**Homestead High School Expansion/Renovation Project
Phase 2B - Gymnasium and Auditorium Additions - General Construction
12.11.20
Addendum No. 3**

Questions and Front End Clarifications - Pre-Bid Meeting - CSO Architects Addendum No. 3

The following information by issuance as Addendum 03 shall be included and become part of the Bidding Documents and therefore part of the Construction Documents.

5 SPARTAN LOGO PATTERN
A800-2 SCALE: 1/4\"/>

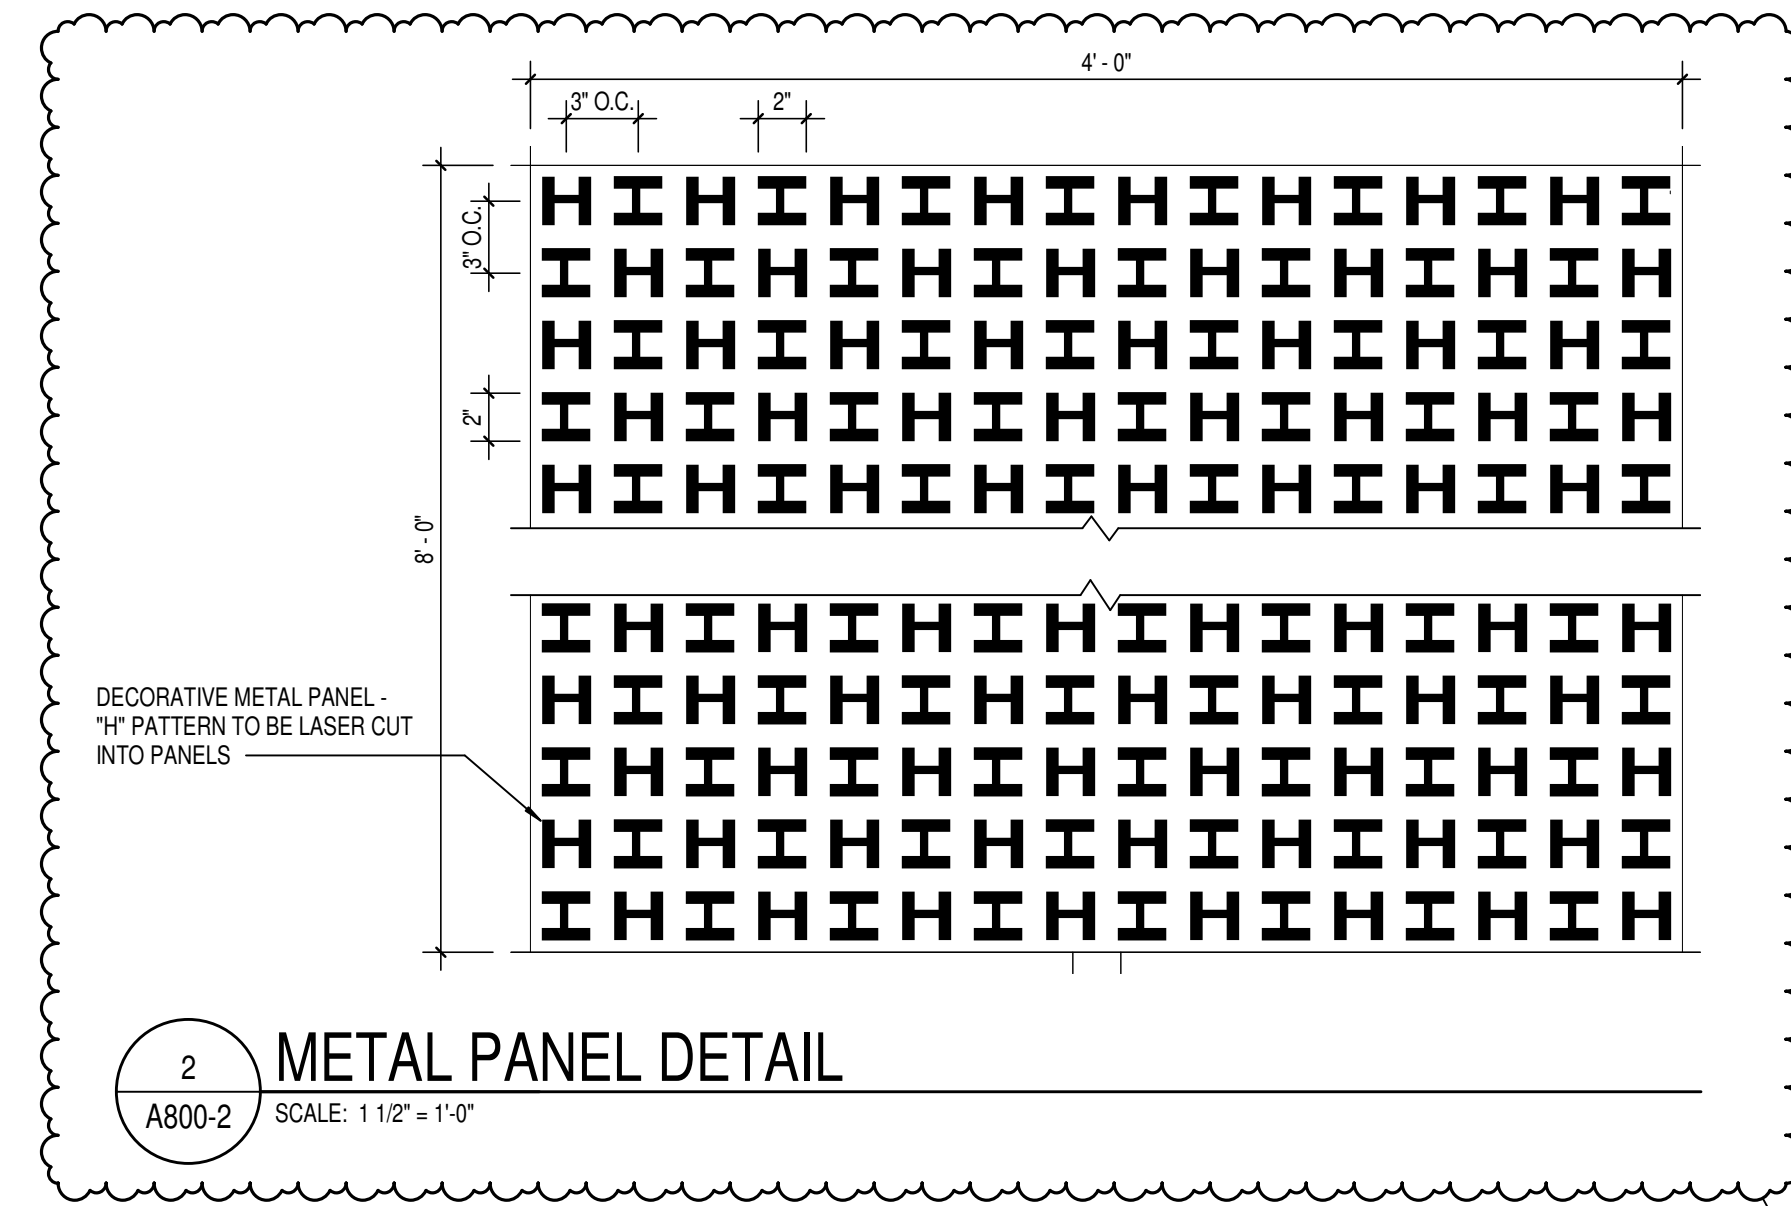
17. In student hallway F121 there looks like a spartan logo, is this to be painted or made from the flooring material? **I am unclear on what this is referencing. Is there a sheet, detail, image to reference?**

EXTERIOR WALL MOCK UP

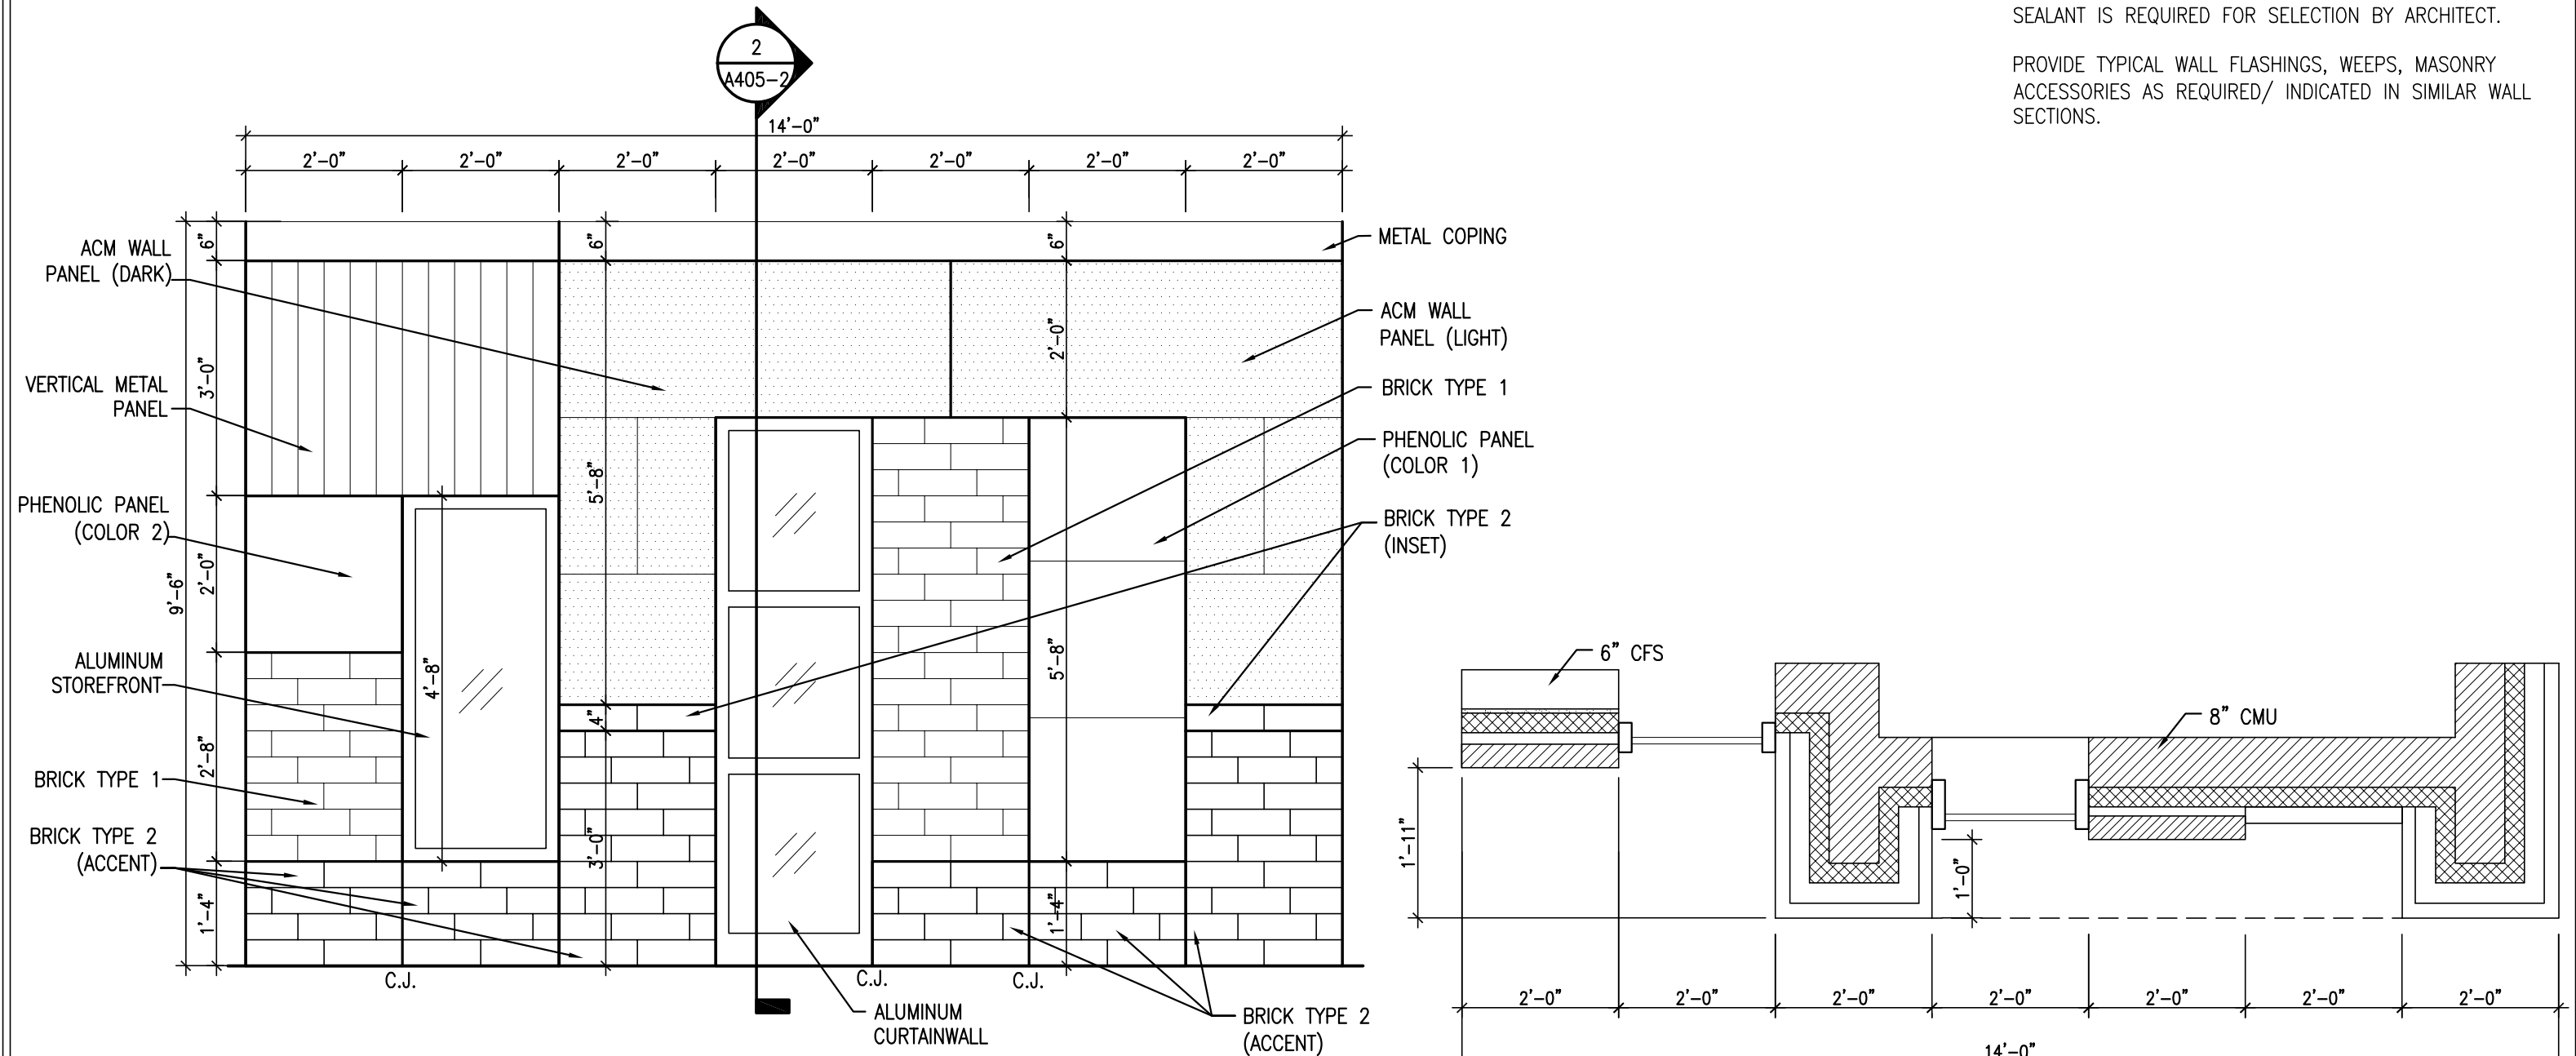
- Item:** 3.12
Location: Chair fabric on the retractable seating platform
Description: Fabric grade shall be Grade G.
- Item:** 3.13
Location: Exterior Wall Mock UP
Description: Reference in CSO Addendum 03 Supplemental Drawing EXTERIOR WALL MOCK UP. Bid Packages 05, 06, (coping only) BP-10, BP-11 and BP-14 are all to participate. Each responsible for caulking their own samples.
